NEW WESTMINSTER

ENQUIRIES AND RESPONSES # 2
NWIT-23-18
SA-16 Sanitary Lift Station Upgrades
New Westminster, BC

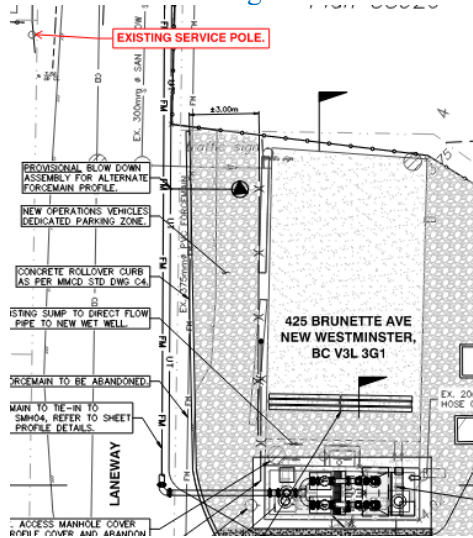
Q40 Dwg 4 of the civil set shows the Hydro pole where the 4" communication conduit is expected to end up. Does the 4" Hydro conduit end at the same pole? The complete routing is not shown on the electrical drawings.

A40 The 4" communication conduit to the base of pol 1-3-172 is not the service for the new pump station, it is an empty conduit for future use.

The 103mm RPVC is to be routed to the existing service pole at the north-east corner of lot 2620, identified in the image below.
